*Application Serial No.: 09/987,035*  
*Art Unit: 2632*

*Attorney Docket No. 6730.03*  
*Confirmation No. 6584*

**Amendments to the Drawings:**

Fig. 5

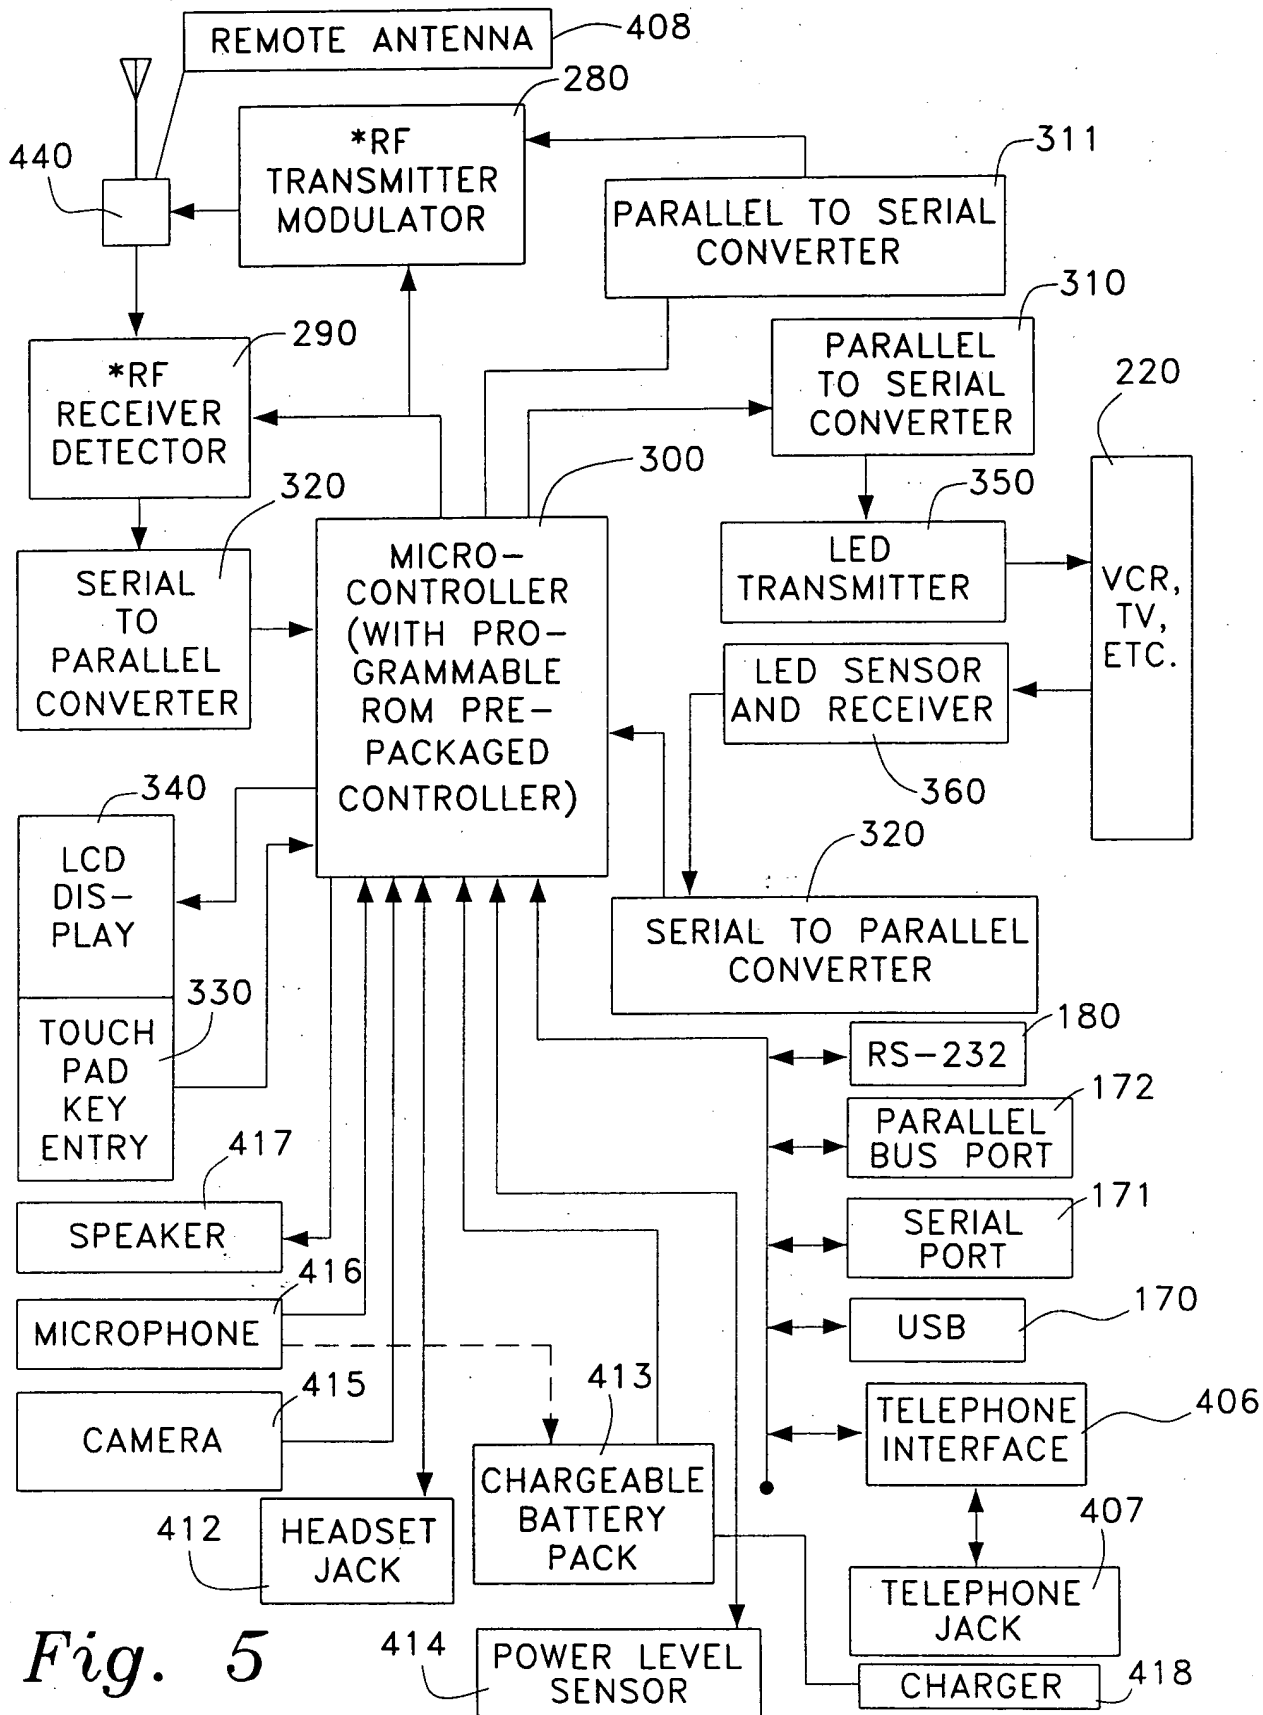
A proposed drawing change is submitted herewith. Proposed changes are shown in red. The attached sheets of drawings include changes to Figs. 5, 6, and 9. These sheets replace the original sheets of Figs. 5, 6 and 9. In Figs. 5, 6, and 9, reference numeral ~~440~~—designating the frequency detector and discriminator element has been added.
